Product Change Notification / RMES-30TIGH578

CCB 4310 Final Notice: Implement Microchip Label, Packing Changes, Part Aging Policy, Recertification and Combination rules for selected Microsemi Chip-Scale Atomic Clocks (CSAC) and Radio Frequency Diode Solutions (RFDS) products.

PCN # RMES-30TIGH578

CSAC Outer Box Label

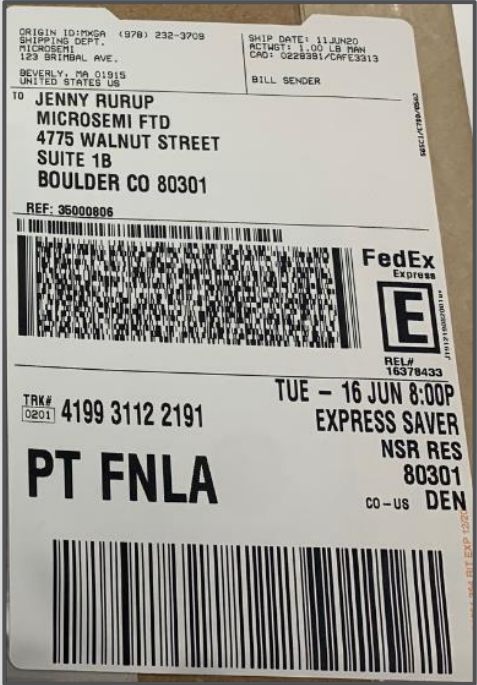
No Microsemi outer box label. Using shipper label

Use Microchip standard outer box label

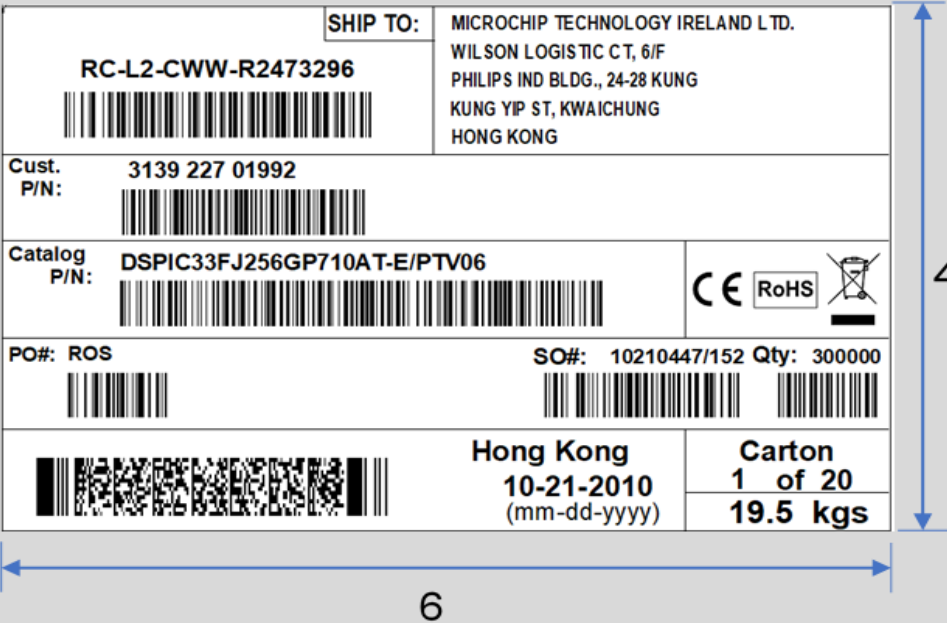
POST-CHANGE

CSAC Inner Carton Printing

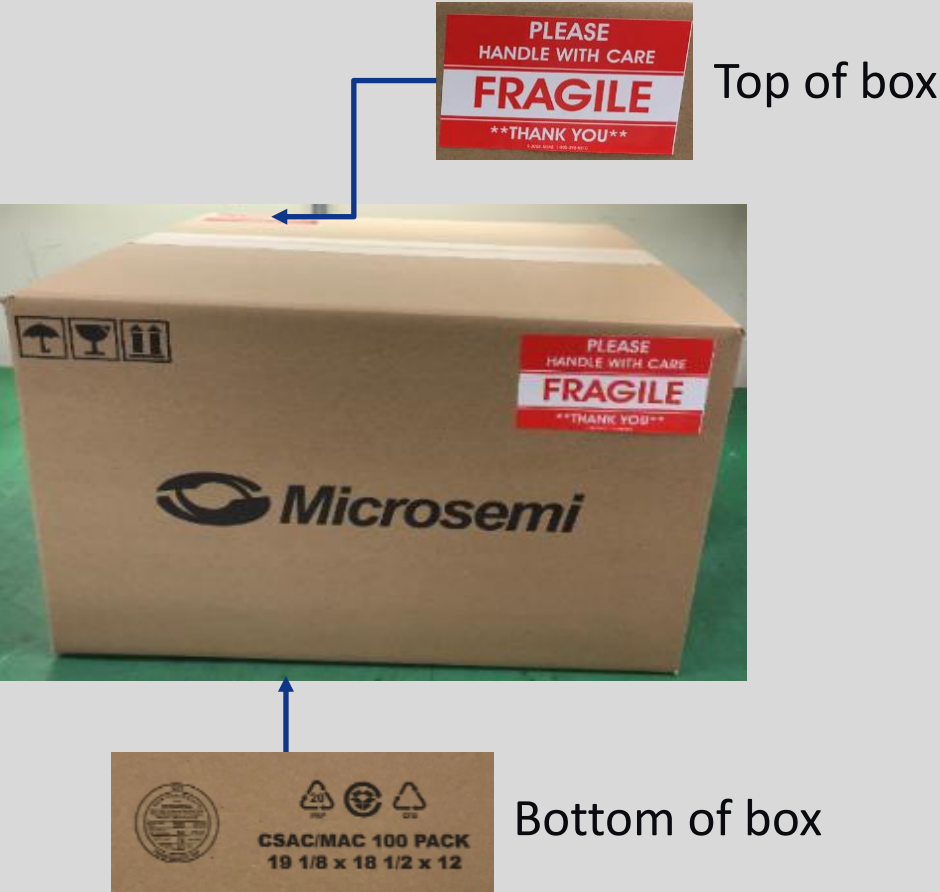
Inner box label without Microsemi Logo

Inner box label with Microsemi Logo

Use Microchip standard inner carton

RFDS Waffle Pack / Reel Labels

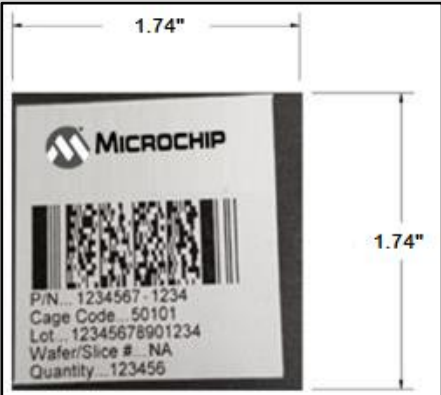
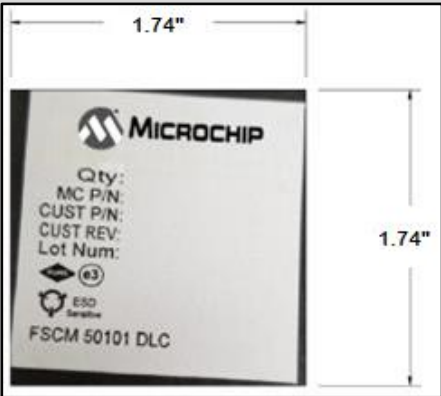
Lowell
General product label, RoHS (if applicable):
Goes on Reel, bag, gel pack, envelope

Use Microchip Logo

RFDS Outer Box Label

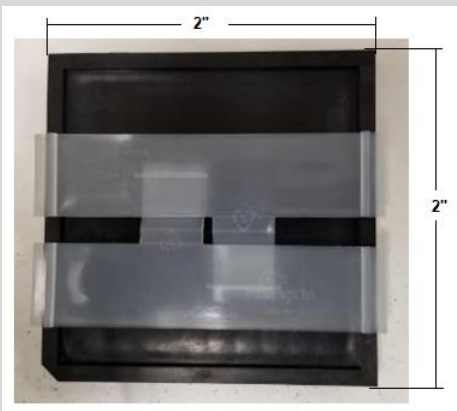
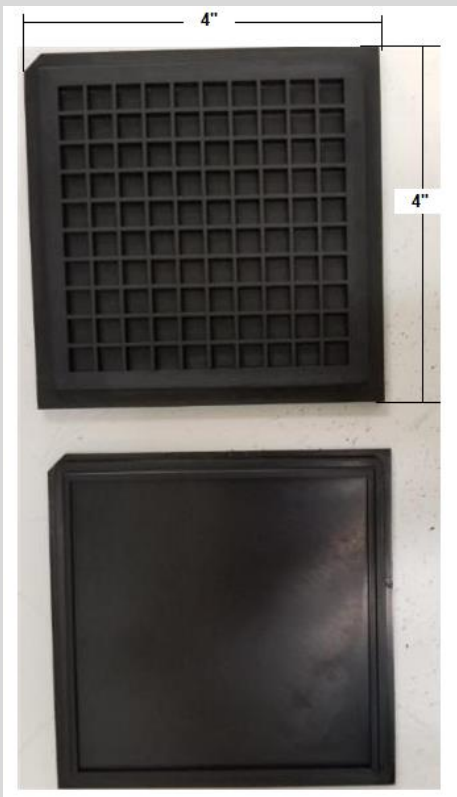
No company label used, only shipping carrier label

Use Microchip standard Outer Box Label

RFDS ESD Caution Sticker

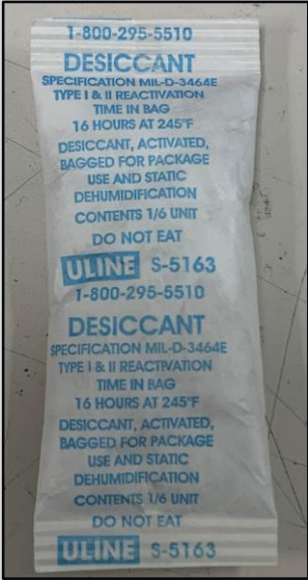
Attached to all initial unit containers

Attached to all outer cartons

Maintain labels used to seal immediate packing
Separate ESD Cautions label will be removed from outer box
ESD Caution labels are already printed on SSB, Inner and Outer cartons

RFDS Desiccant

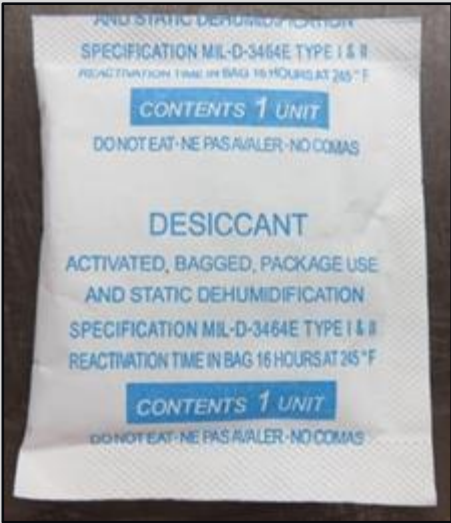
Silica Gel

Use desiccant per customer requirements

Use Microchip standard
Will be used as required
Desiccant Clay

RFDS Moisture Sensitivity Caution Label

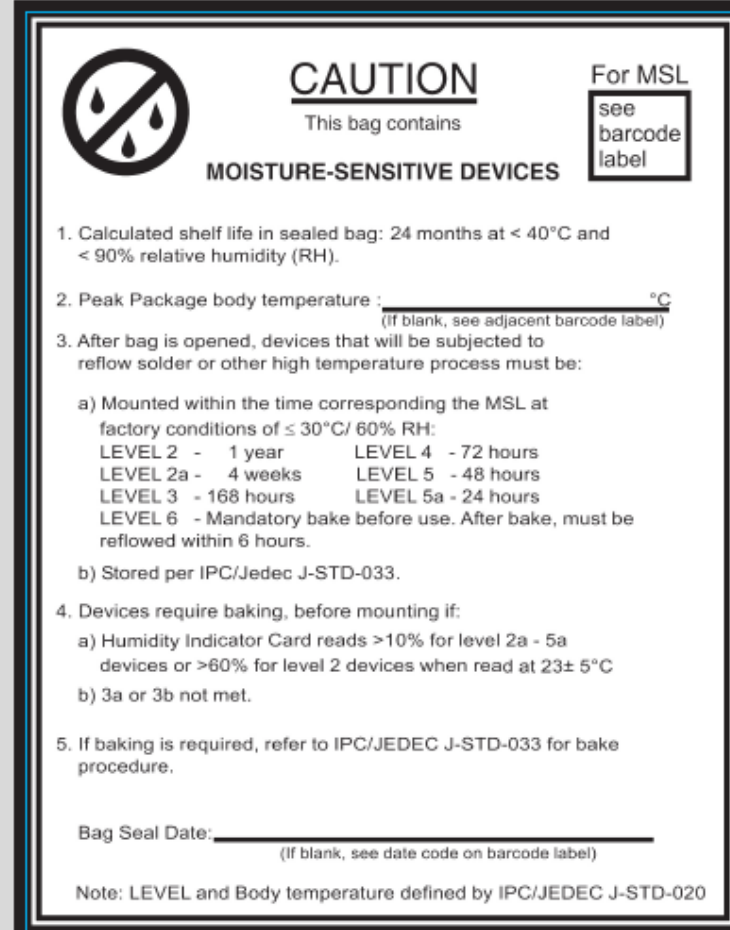
1. Calculated shelf life in sealed bag: 12 months at $< 40^{\circ}\text{C}$ and $< 90\%$ relative humidity (RH).
2. Peak package body temperature: _____ $^{\circ}\text{C}$
If Blank, see adjacent bar code label

3. After bag is opened, devices that will be subjected to reflow solder or other high temperature process must
a) Mounted within: _____ hours of factory
If Blank, see adjacent bar code label
conditions $\leq 30^{\circ}\text{C}/60\%$.

b) Stored at $< 10\%$ RH.
4. Devices require bake, before mounting, if:
a) Humidity Indicator Card is $> 10\%$ when read at $23 \pm 5^{\circ}\text{C}$
b) 3a or 3b not met.

5. If baking is required, devices may be baked for 48 hours at $125 \pm 5^{\circ}\text{C}$.
Note: If device containers cannot be subjected to high temperature or shorter bake times are desired, reference IPC/JEDEC J-STD-033 for bake procedure.
Bag Seal Date: _____
If Blank, see adjacent bar code label
Note: Level and body temperature defined by IPC/JEDEC J-STD-020

RFDS Humidity Identification Card (HIC)

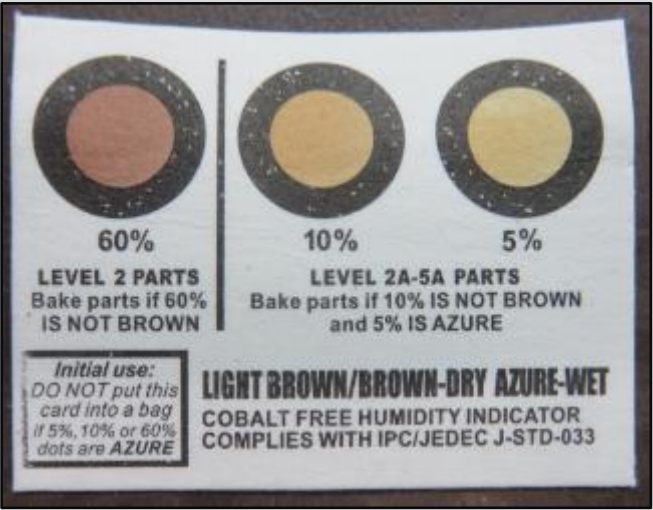
6 Dots (10%, 20%, 30%, 40%, 50%, 60%)

3 Dots (5%, 10%, 60%)
Cobalt Free
